FAP NO.	SECTION	COUNTY	TOTAL SHEETS	SHEET NO.
05-00016-03-BR	MADISON	129	24	
STA. 38+00		TO STA. 43+50		
CONTRACT NO.: 97351				
ADDENDUM #1 01-02-2009

ILLINOIS DEPARTMENT OF TRANSPORTATION
GRADING PLAN
STA. 38+00 TO 43+50
FAU ROUTE 8959
SECTION 05-00016-03-BR
COUNTY MADISON
 DRAWN BY: R.A.W.

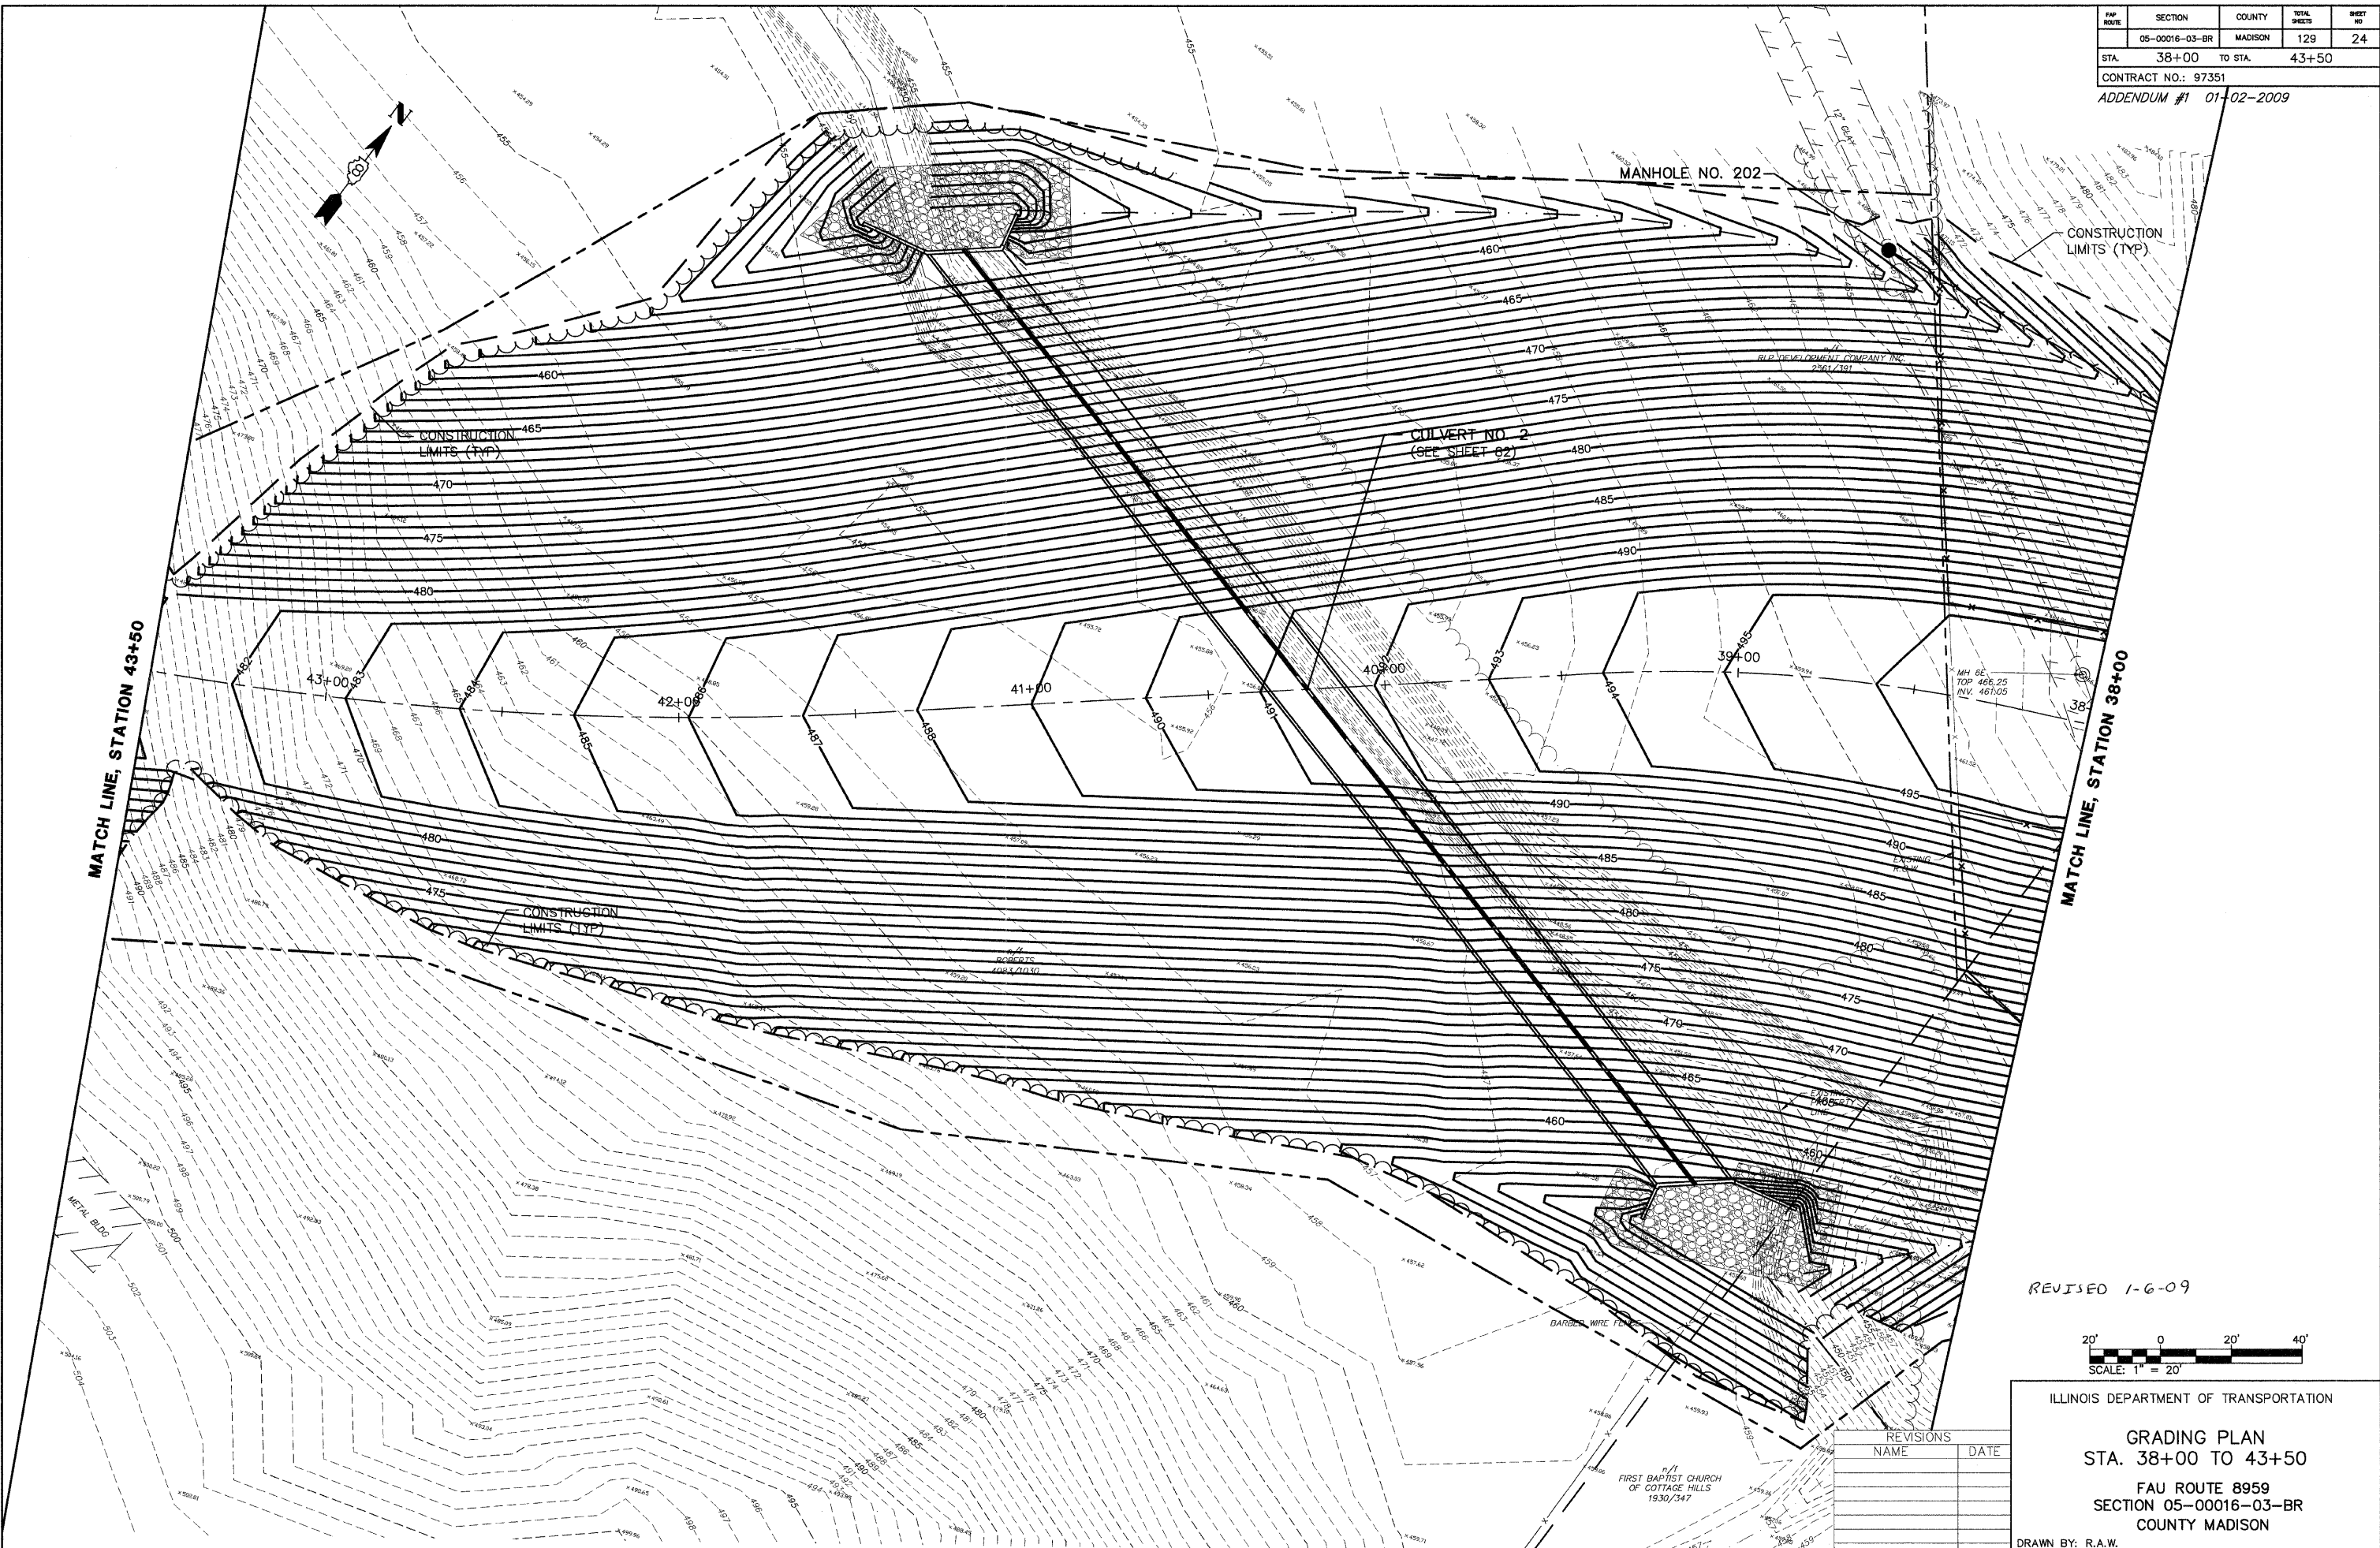
REVISED 1-6-09
